**STATE OF HAWAII
DEPARTMENT OF TRANSPORTATION
HIGHWAYS DIVISION**

ADDENDUM NO. 3

**MOANALUA FREEWAY
HIGHWAY LIGHTING IMPROVEMENTS
HALAWA HEIGHTS OFF-RAMP TO MIDDLE STREET OVERPASS
FEDERAL-AID PROJECT NO. NH-H201(005)**

**DISTRICT OF HONOLULU
ISLAND OF OAHU
FY 2017**

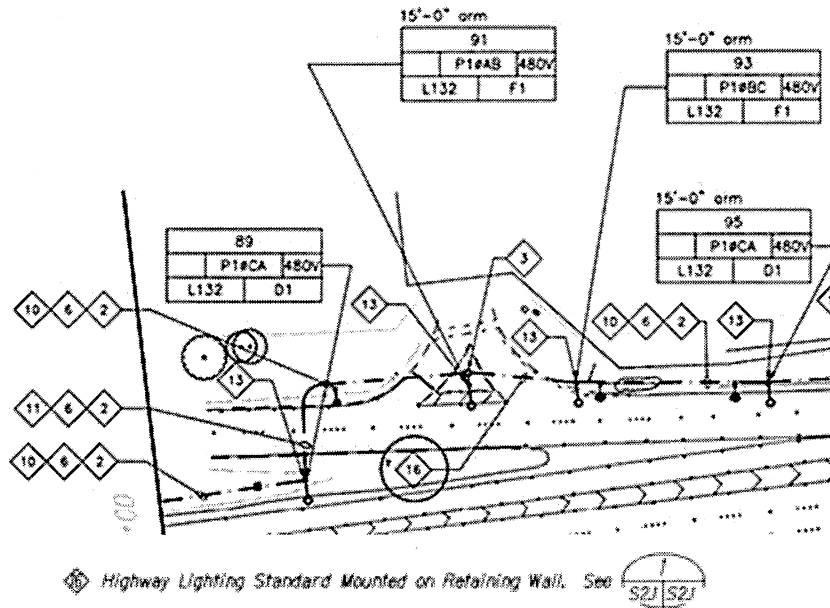
In sheet 121, there are two notes that make reference to communication conduits: Note 6 (2-2") and Note 19 (3-2"). Note 19 indication is not found anywhere in the lightning plans.

6 Communication Conduits 2-2".

19 Communication Conduits 2-2" and Power Conduit 1-2" (3-2" Total).

Questions:

- (a) Are there any 3-2" communication conduits in the project?
 HDOT Response: No. The bid proposal has been revised to clarify.
- (b) If so, can you indicate in the plans where 3-2" communication conduits are located? n/a
